IMPORTANT SAFETY RETROFIT NOTICE

INFORMATION BULLETIN NO. 32

**TO: ALL OWNERS, OPERATORS AND REBUILDERS OF
FLETCHER DD TRACK DRILLS WITH ELEVATING BOOMS**

SUBJECT: BOLTS ON BOOM SWING TURNTABLE

| SHEET NO. 0032-A | TITLE SERVICE BULLETIN | DATE 09-17-1986 | R J. N. FLETCHER & CO. 701 WEST 7TH STREET HUNTINGTON, W. VA. |

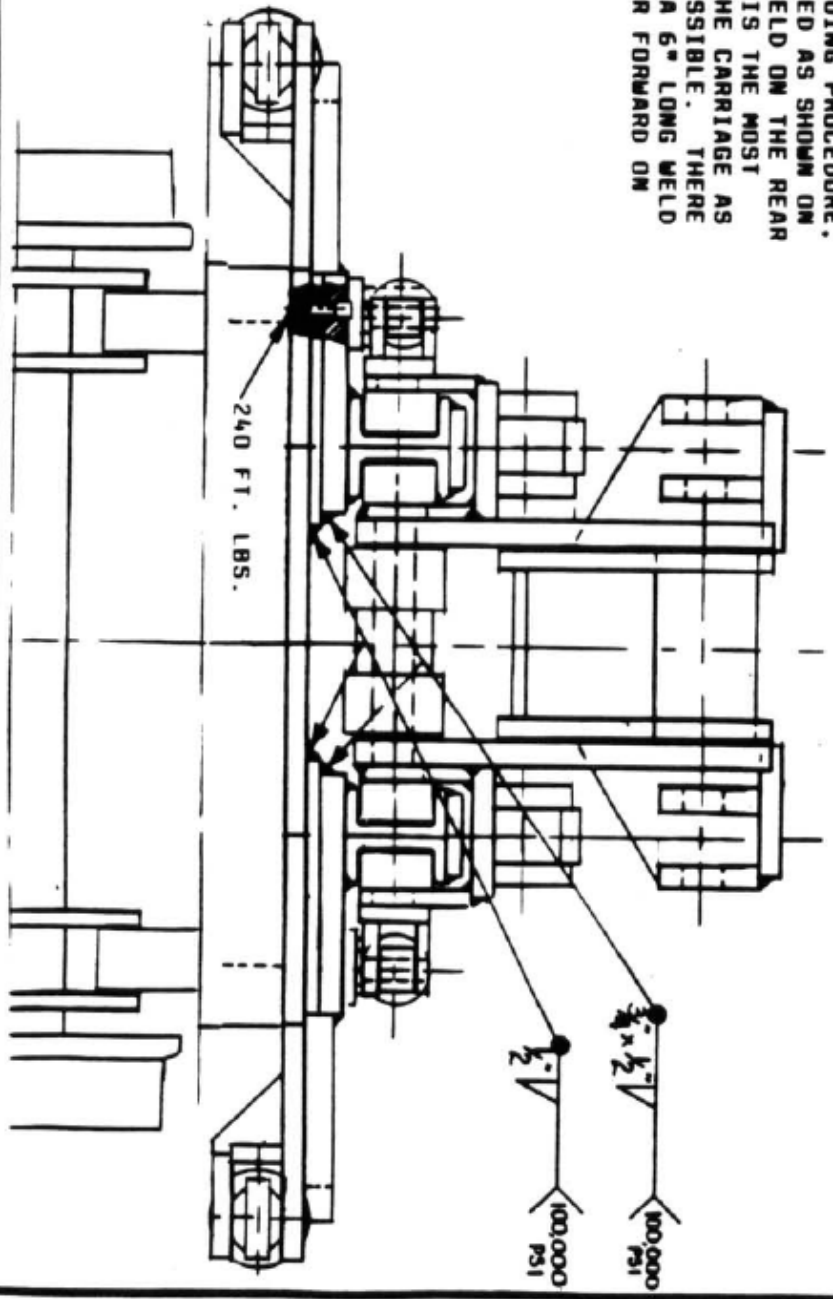
PROBLEM: Bolts holding the boom swing turntable to the slewing ring (or bearing) may break, allowing the boom to drop.

BACKGROUND: The boom swing turntable is made up of three layers of plates. On several machines these plates were not welded together. As a result, the bolts under the back of the boom, between the sump assembly and the turntable, are subjected to an excessive tensile load which could cause the boom to drop.

IF CARRIAGE MOUNT IS NOT WELDED AS THE DRAWING BELOW NOTES THEN USE THE FOLLOWING PROCEDURE:

REPLACE ALL 5/8-11 x 4" (14) SOCKET HEAD CAP SCREWS AND TORQUE TO 240 FT. LBS. (CHECK TORQUE ON REMAINING BOLTS TO THE SAME TORQUE VALUE). AFTER COMPLETION OF BOLT EXCHANGE AND TIGHTENING PROCEDURE, WELDING IS REQUIRED AS SHOWN ON DRAWING BELOW. WELD ON THE REAR OF THE TURNABLE IS THE MOST CRITICAL. SLUMP THE CARRIAGE AS FAR FORWARD AS POSSIBLE. THERE MUST BE AT LEAST A 6" LONG WELD PASS FROM THE REAR FORWARD ON ALL FOUR JOINTS.

240 FT. LBS.

0032-8

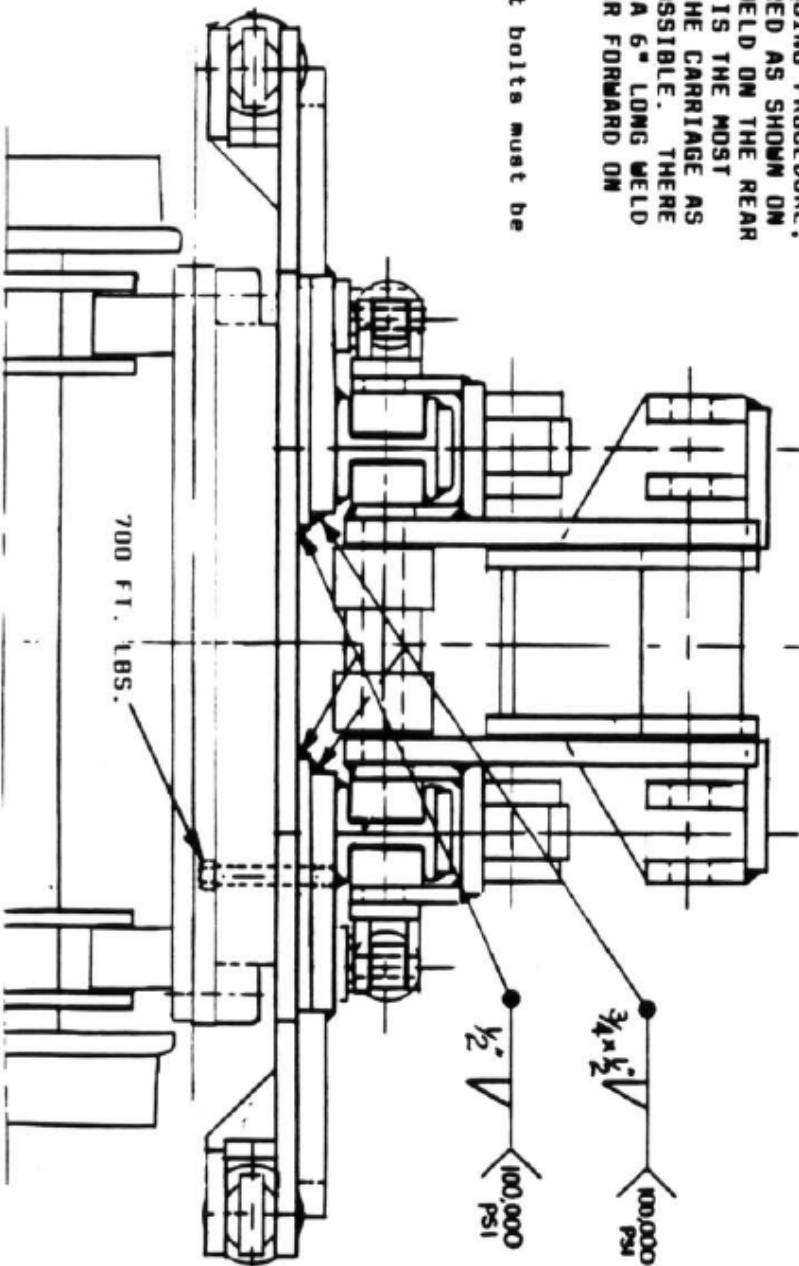
IF CARRIAGE MOUNT IS NOT WELDED AS THE DRAWING BELOW NOTES THE USE THE FOLLOWING PROCEDURE:

REPLACE ALL 7/8-9 x 5 1/2" (12) HEX HEAD CAP SCREWS AND TORQUE TO 700 FT. LBS. (CHECK TORQUE ON REMAINING BOLTS TO THE SAME TORQUE VALUE). AFTER COMPLETION OF BOLT EXCHANGE AND TORQUING PROCEDURE, WELDING IS REQUIRED AS SHOWN ON DRAWING BELOW. WELD ON THE REAR OF THE TURNABLE IS THE MOST CRITICAL. SUMP THE CARRIAGE AS FAR FORWARD AS POSSIBLE. THERE MUST BE AT LEAST A 6" LONG WELD PASS FROM THE REAR FORWARD ON ALL FOUR JOINTS.

Note: Replacement bolts must be

Grade 8
